AMENDMENT OF SOLICITATION/MODIFICATION OF CONTRACT

10-0031 Repair BEQ Building BB260 Temporary Trailer Telecommunications Requirements

Section 01 59 00 Temporary Trailers for Displaced Tenants

SITE ELECTRICAL DEMOLITION & NEW WORK PLAN
 SCALE: 1" = 20'

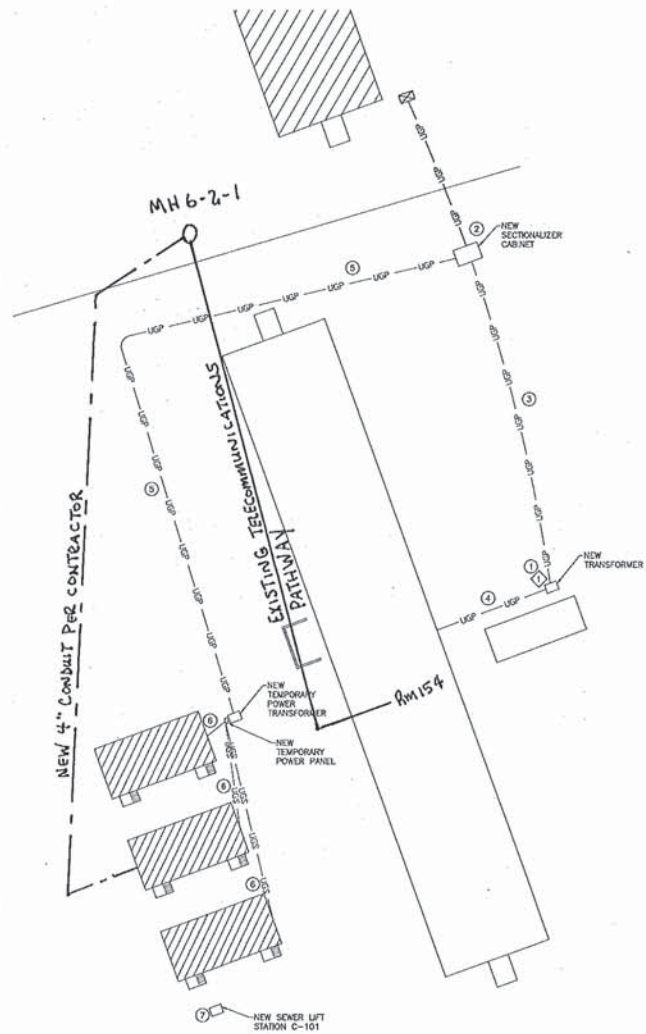
o. Contractor shall install 1-4" Conduit, with Outside Plant 12 strand shielded fiber with Corning glass and Outside Plant PE-39 25 pair copper cable, from the center telecommunications trailer to Man Hole 6-2-1. See attached sketch of new 4" conduit, per contractor, and existing conduit. The exact location of new and existing shall be determined/located by contractor. The contractor is responsible for surveying the work area to locate all existing utilities. The contractor is responsible for any damage done to the existing utilities. The contractor shall install/extend the new Outside Plant 12 strand shielded fiber with Corning glass and Outside Plant PE-39 25 pair copper, in the existing conduit, from Man Hole 6-2-1 to the existing telecommunications room 154 in BB260 and terminate on rack/cabinet at both ends. The contractor shall adhere to 33 82 00 Telecommunications Outside Plant specifications for proper installation of conduits. Conduits shall terminate underneath the center trailer (near telecomm cabinet). Preserve and protect the existing outside plant (OSP) telecommunications. The contractor is responsible for all telecommunications pathway and infrastructure. The contractor is to ensure that the temporary trailers have a complete and usable telecommunications system. Once construction has been completed the contractor shall remove cabling, conduit, and equipment that was previously provided by contractor.

Provide a separate 4" PVC conduit underground from telecomm trailer to other trailers for telecommunications cabling installation/pathway. Conduits shall be installed after trailers have been placed and set up. Conduits shall use long sweeps at all changes of direction. Inside radius of conduit shall be at least 24". Conduits shall have no more than 180 degrees of total change in direction. Conduits shall be installed with pull wire accessible from both ends and both ends shall be capped.
